# PRE-GATEWAY REVIEW - Information Assessment and Recommendation Report

LGA:	Leichhardt		
Amended LEP:	Leichhardt Local Environmental Plan 2013		
Address:	245 Marion Street, Leichhardt		
Reason for review:	Council notified proponent it will not support proposed amendment	Council failed to indicate support for proposal within 90 days	
Is a disclosure statement relating to reportable political donations under s147 of the Act required and provided?	☐ Provided  Comment: There are no donations or	⊠ N/A gifts to be disclosed.

Figure 2: Current and Proposed land zoning controls. Source: Andrew Wilson 2014 & NSW Legislation 2015

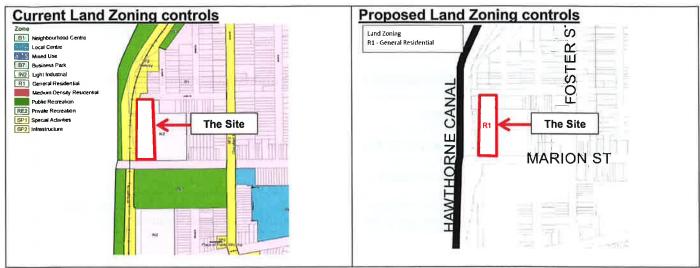
The planning proposal contains sufficient images illustrating the site in context, but does not contain sufficient mapping consistent with the Standard LEP mapping guidelines. Whilst the proposal identifies the proposed zoning, floor space ratio and height controls for the site, it does not indicate the relative floor space ratio and height controls applying to the surrounding properties. Should the proposal proceed to Gateway, the planning proposal will need to be updated to provide detailed maps of the current and proposed amendments in context.

Figure 4: Current and Proposed building height controls. Source: Andrew Wilson 2014 & NSW Legislation 2015

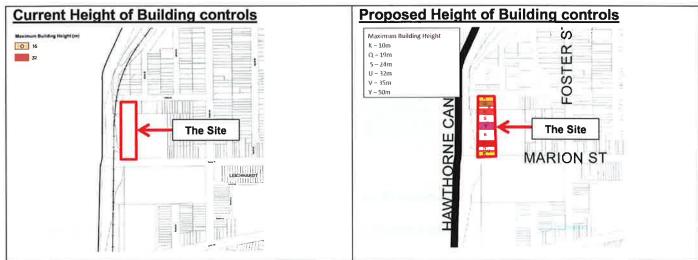
The proposal does present variation in height across the site however seeks a maximum height of up to 50 metres on the site (approximately 15 storeys). The proposed height and density is above the maximum proposed under the Strategy.

It is also noted the proposed heights exceed the heights proposed for the Taverners Hill Precinct, which will range from 17-42 metres (i.e. maximum of 12 storeys).
